**PROJECT FOR COMPREHENSIVE FLOOD MANAGEMENT PLAN FOR
THE CHAO PHRAYA RIVER BASIN IN KINGDOM OF THAILAND**

MINUTES OF MEETING
ON
THE STEERING COMMITTEE MEETING FOR SUBCOMPONENT 1-2 AND COMPONENT 3
OF
PROJECT FOR COMPREHENSIVE FLOOD MANAGEMENT PLAN
FOR THE CHAO PHRAYA RIVER BASIN IN THE KINGDOM OF THAILAND

MINUTES OF MEETING
ON
THE TECHNICAL GROUP MEETING FOR SUBCOMPONENT 1-2
OF
PROJECT FOR COMPREHENSIVE FLOOD MANAGEMENT PLAN
FOR THE CHAO PHRAYA RIVER BASIN IN THE KINGDOM OF THAILAND

SKEMATIC DIAGRAM
LOCATION OF SUGGESTED CHANGE ON HYDROLOGICAL STATIONS

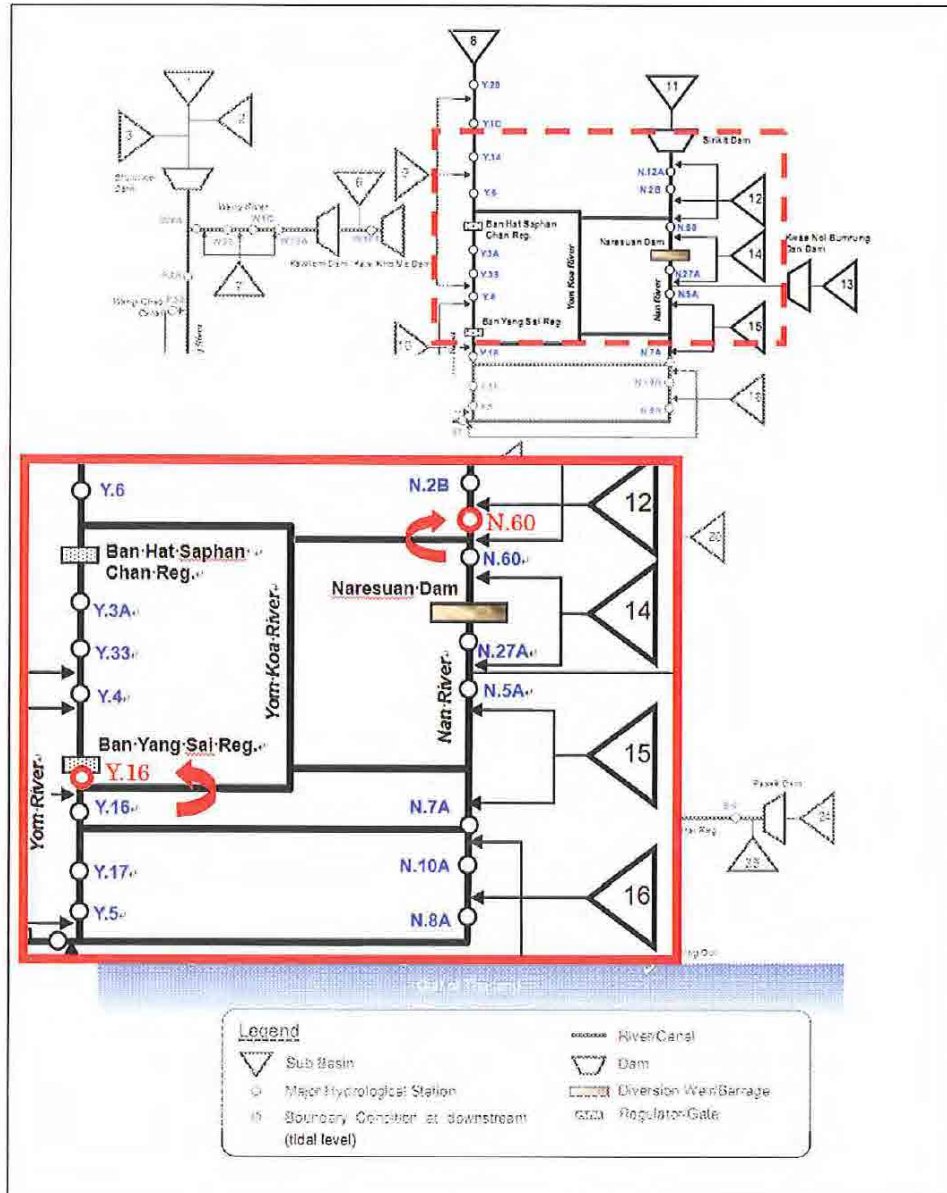
RID suggested that the location of hydrological stations of Y.16 and N. 60 be changed to the right locations in the schematic diagram shown in Figures 1.3.3, 1.6.1 and 1.6.2 in the meeting material. The suggested locations are shown in Annex 4. The Study Team agreed on the change.
